ADDENDUM #02

PROJECT: **RENOVATIONS TO PALMERTON WEIGHT ROOM**
ISSUE DATE: Tuesday, March 5th 2024

RENOVATIONS TO PALMERTON HIGH SCHOOL WEIGHT ROOM

A4.00

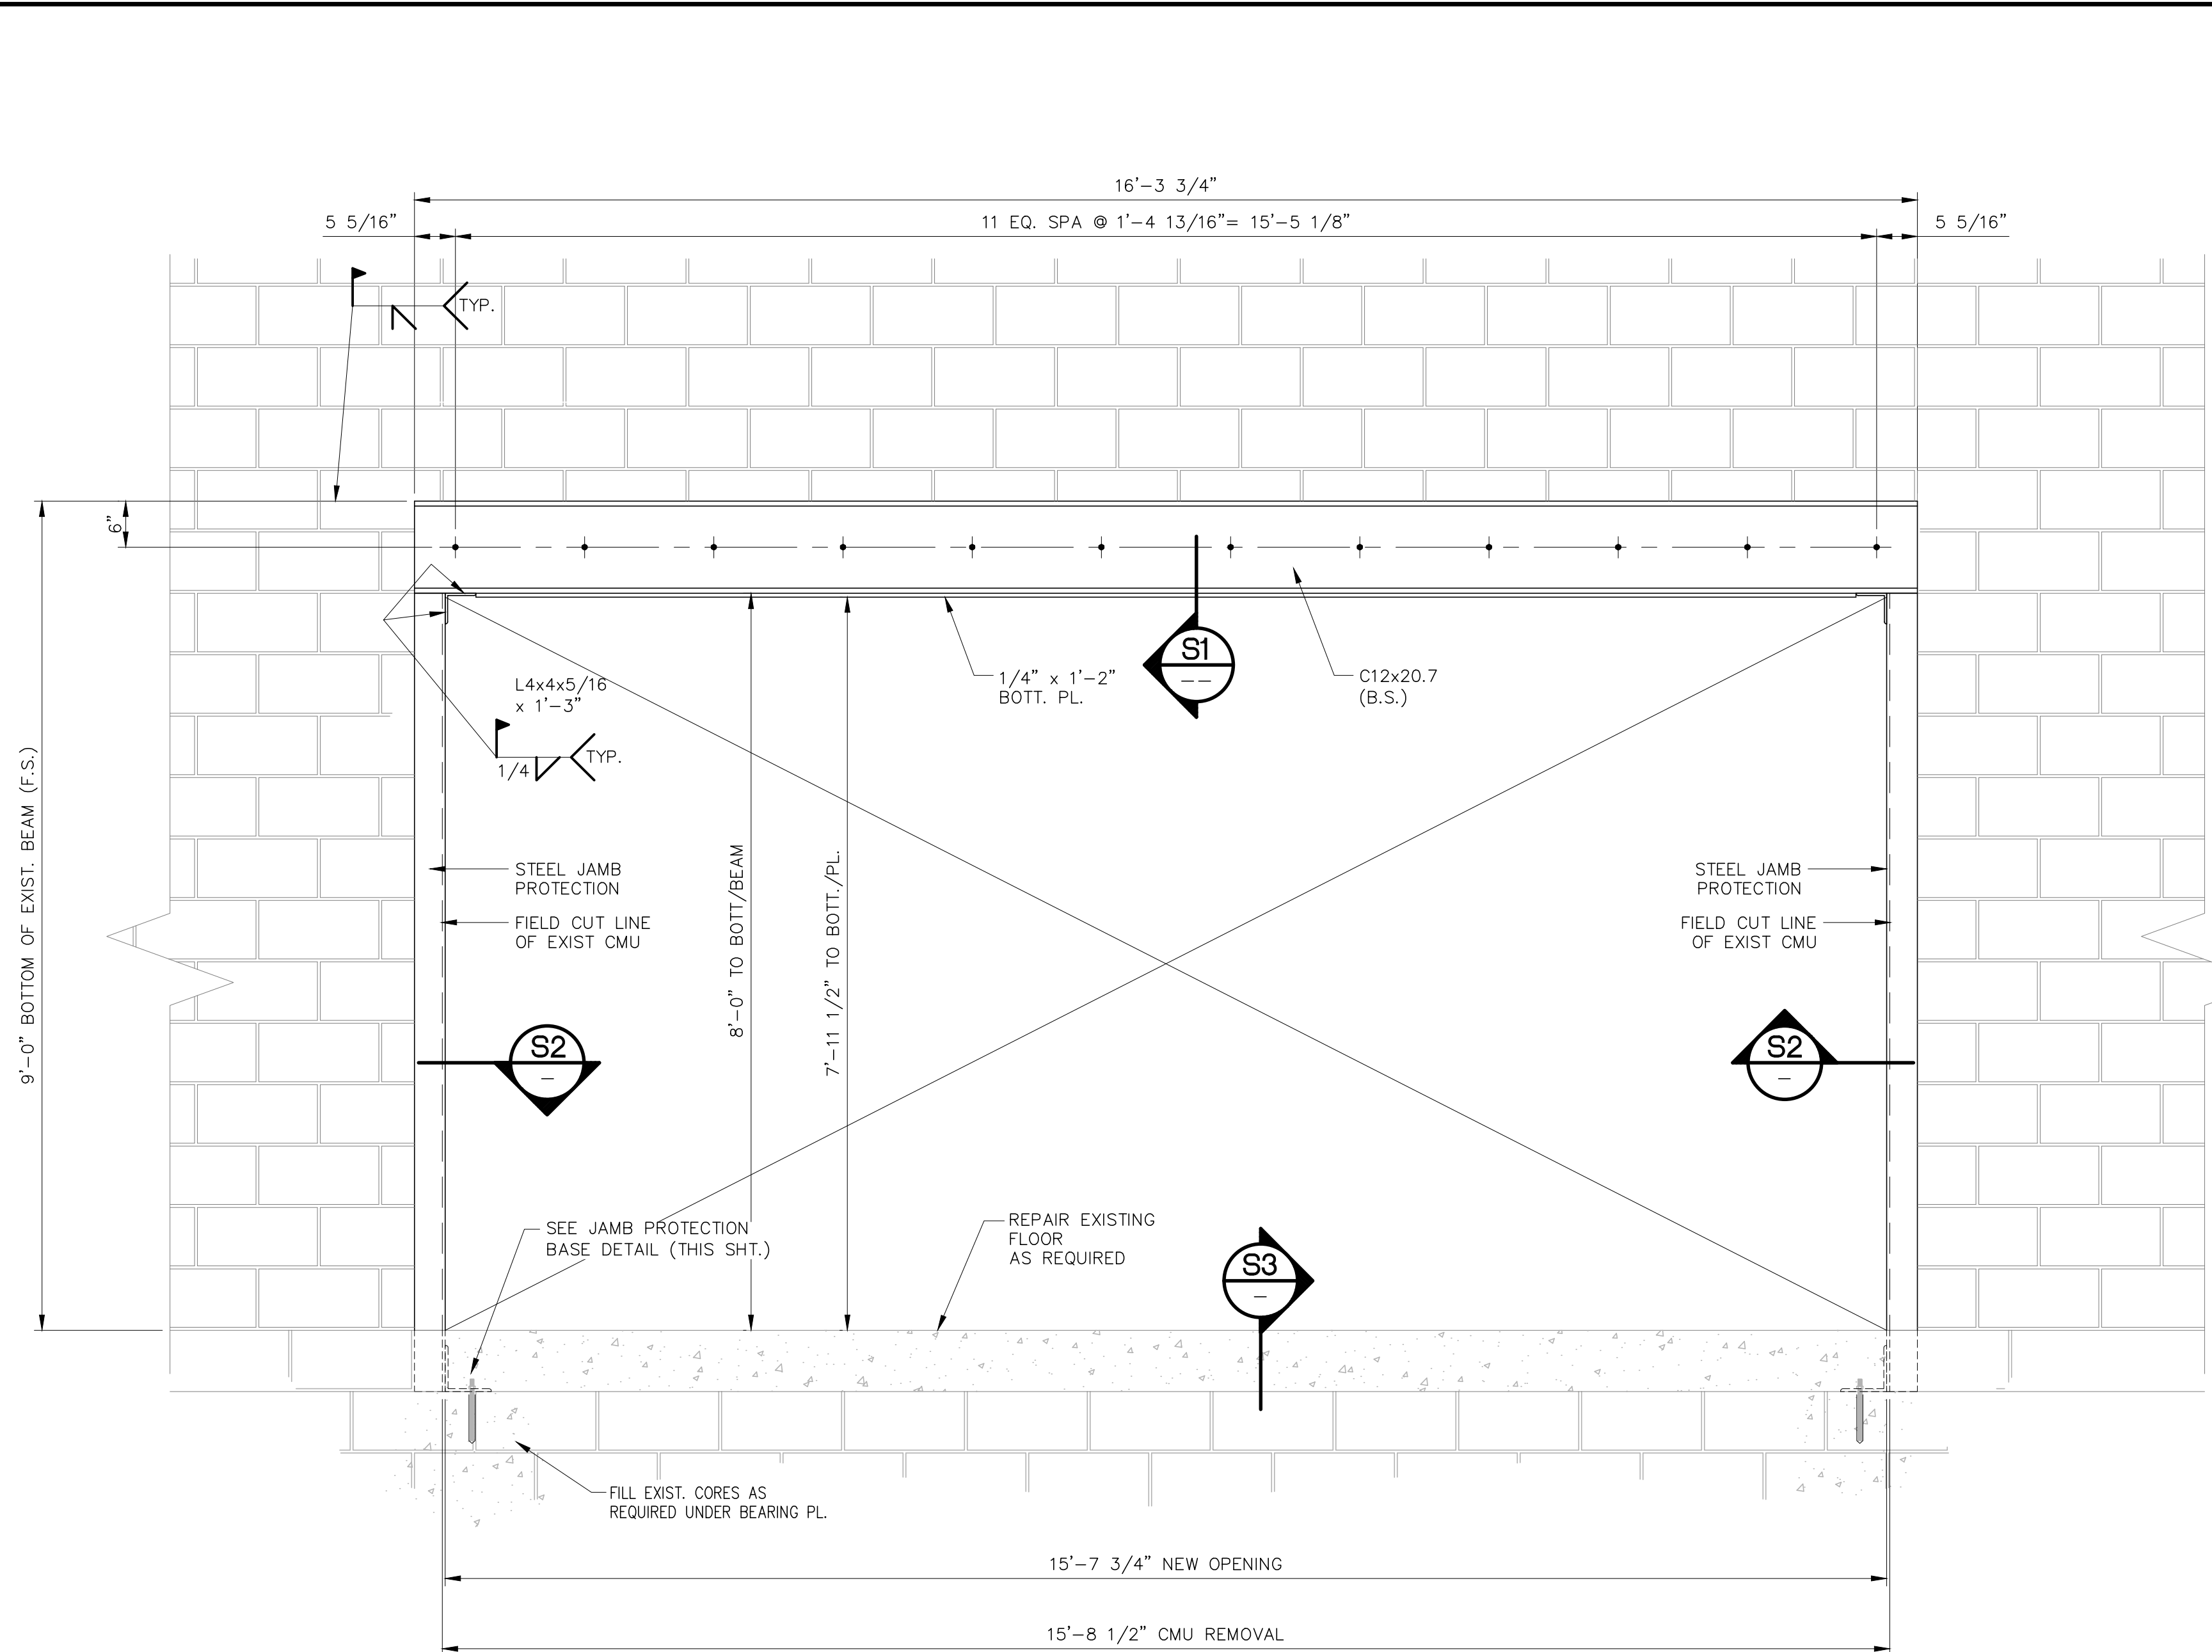
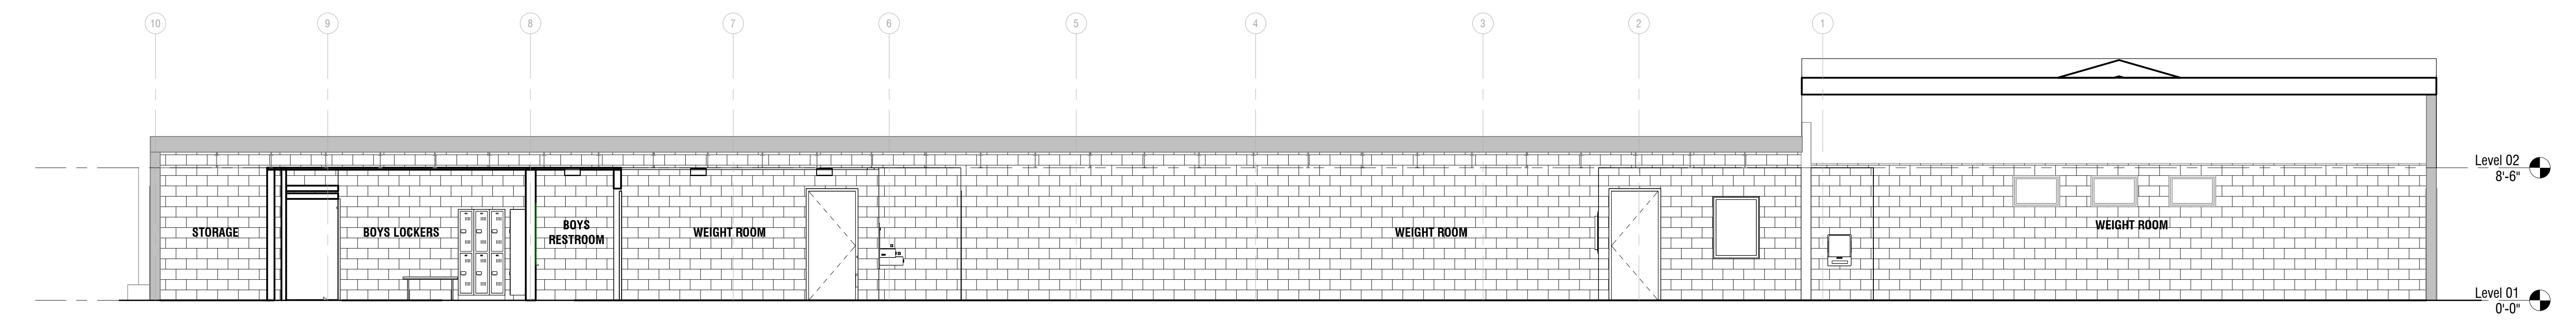
A4.00 – WALL SECTIONS

- Updated concrete slab information.
